Re: Drainage Control Ordinance (14-5-2-1) and NPDES CGP Violations for Erosion and Sediment Control and Pollution – La Luz Del Oeste Unit 4

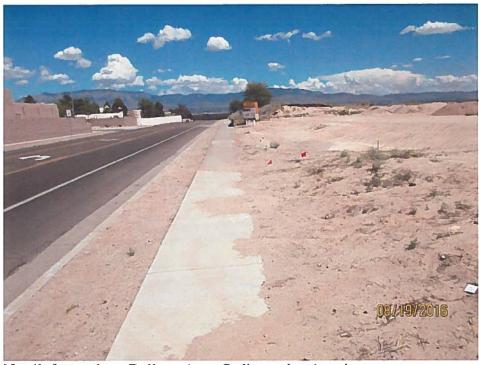
No silt fence along Dellyne Ave. Sediment leaving site.

1. Install silt fence along project boundary along Dellyne Rd and remove sediment from the sidewalk.

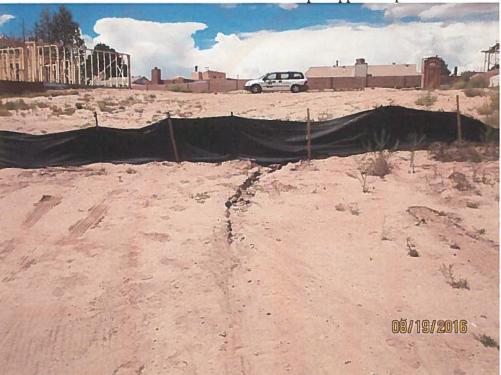
Construction entrance not maintained.

- 2. Improve the construction entrance to Erosion Control Plan specifications.
- 3. Install the series of wattles across the road to Mill Rd. per the Erosion Control Plan.
